National Environmental Consulting

February 22, 2022

Subject: Proposed Modifications to the OU2 Groundwater On-Site Containment System, Tower 102 Treatment System
Northrop Grumman Systems Corporation
Bethpage, New York

SYMBOL		ZONE	DESCRIPTION	DATE	APPROVED
REVISIONS					
DATE		NORTHROP GRUMMAN SYSTEMS CORPORATION BETHPAGE, NEW YORK			
DRAWN	MH				
CHECKED	CT				
ENGINEER	CT				
FIGURE 1 PROCESS AND INSTRUMENTATION DIAGRAM AIR PROCESS					
APPROVED	DATE	SIZE	DWG. NO.	REV	
TITLE		PROJ. NO. 000.07AS301121		SHEET

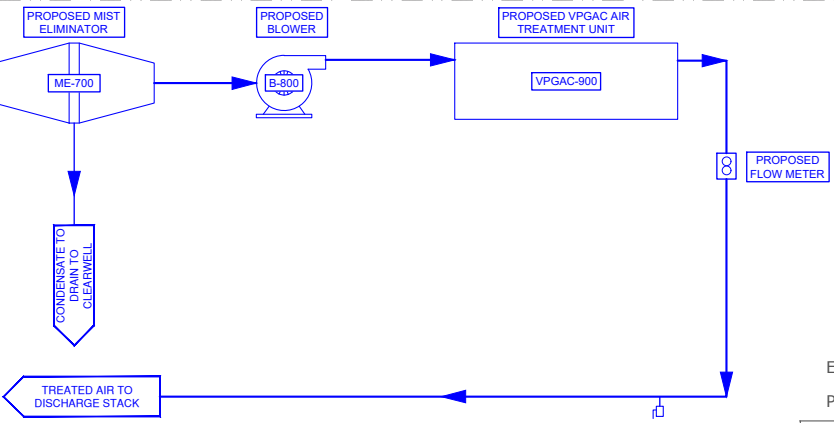
Northrop Grumman plans to bypass the RVPGAC system and associated equipment to provide continued treatment of T102 vapors through the VPGAC unit. **Figure 1 and Figure 2** illustrate the modifications that will be made to the current system. Figure 1 and Figure 2 are based on the Air Treatment Process and Instrumentation Flow Diagrams provided in the OU2 Operation, Maintenance and Monitoring (OM&M) Manual (Arcadis, May 2014). The modifications are summarized as follows:

1. Bypass the following RVPGAC system equipment inside the T102 building through installation of new duct work using round 6061 aluminum alloy with 0.25-inch wall thickness and welded 0.25-inch-thick flanges and corrosion resistant assembly hardware and connections:

- v. Condensate receiving tank and associated level switch and pumps.
2. Installation of a new Hartzell Q05-1-294AH100STFCV3 blower (B-800) and 75-horsepower (hp) motor along with electrical conduit, power, and indicators and switches. The new vapor

- treatment blower-and motor are the same model as the existing B-500 except they are rated for outdoor use. The blower can overcome all losses across the system.
3. Installation of an exterior concrete equipment pad between the air stripping tower and the building for the new blower.
 4. Installation of a 10,000 cfm Midwest Air Products Company vertical inline one-stage mist eliminator with remote-mounted magnehelic gage.
 5. Installation of a V400C, TetraSOLV, 40,000-pound VPGAC unit.
 6. Installation of a Vor-Tek T-VTS130-2X2-31 air flow transmitter and meter.

- EQUIPMENT OR CONTROLS TO BE BYPASSED
- PLANNED SYSTEM MODIFICATIONS

SYMBOL		ZONE	DESCRIPTION	DATE	APPROVED
REVISIONS					
DATE	NORTHROP GRUMMAN SYSTEMS CORPORATION BETHPAGE, NEW YORK				
DRAWN	MH				
CHECKED	CT				
ENGINEER	CT				
FIGURE 2 PROCESS AND INSTRUMENTATION DIAGRAM AIR PROCESS					
APPROVED	DATE		SIZE	DWG. NO.	REV
TITLE			PROJ. NO. 000.07AS301121	SHEET

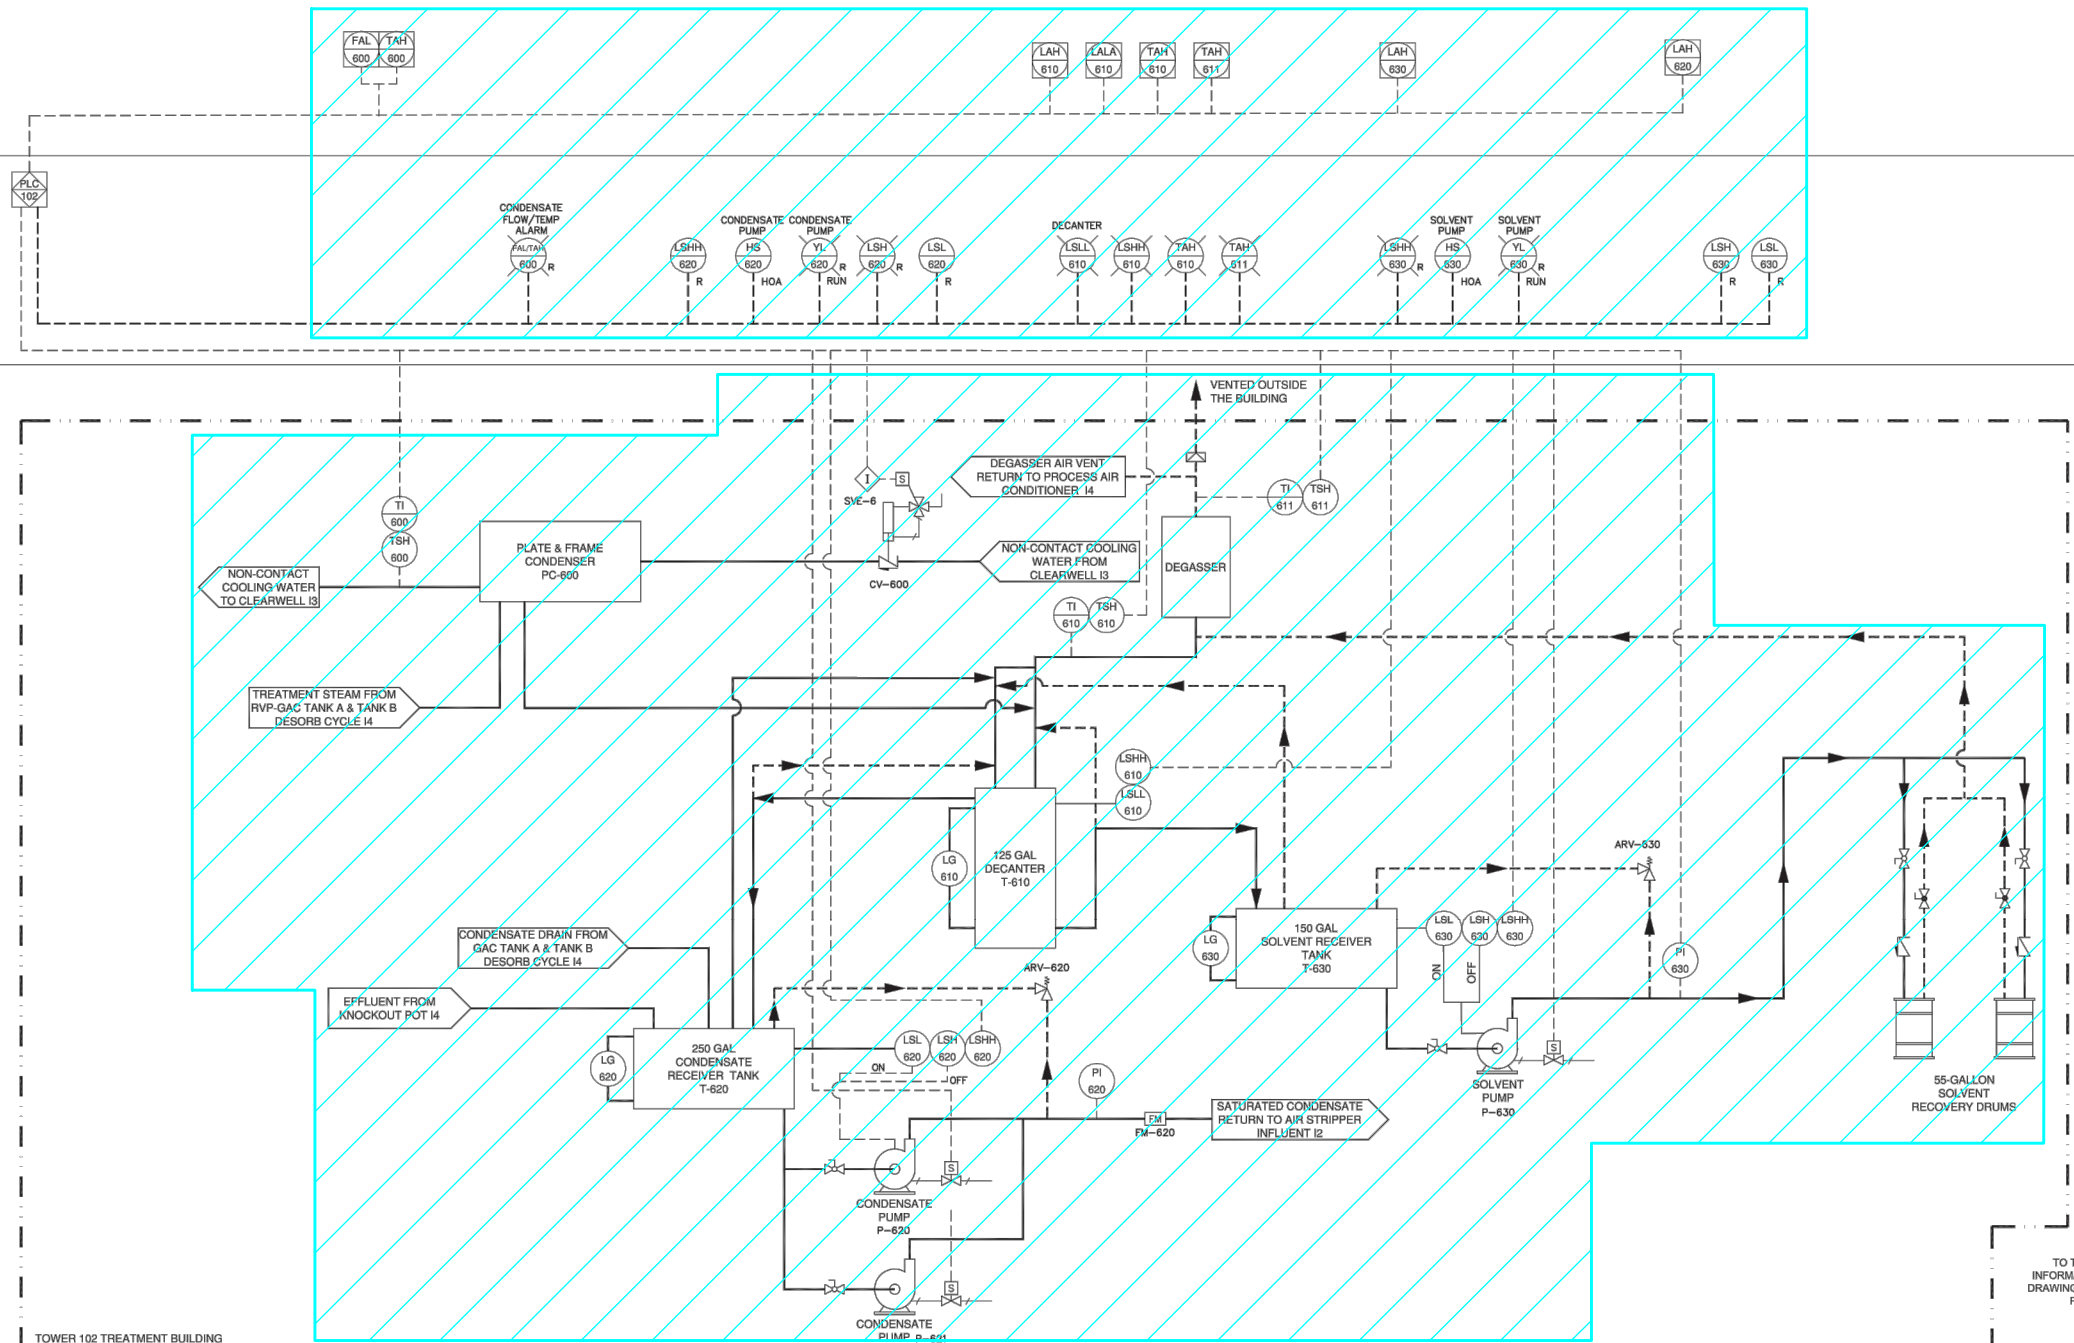
- a. Vapor treatment steam system;
 - i. Mist eliminator and associated temperature indicators, knockout tank and pump, and associated level switches and pressure indicator;

- v. Two RVPGAC units and associated pressure indicators and valves;
 - b. Solvent recovery system including:
 - i. Plate and frame condenser and associated switches and valve;

- ii. Decanter and associated switches;
 - iii. Degasser and associated indicator;
 - iv. Solvent receiver tank, pump, transmitter, level indicator, and drums; and

EQUIPMENT OR CONTROLS TO BE BYPASSED

PLANNED SYSTEM MODIFICATIONS
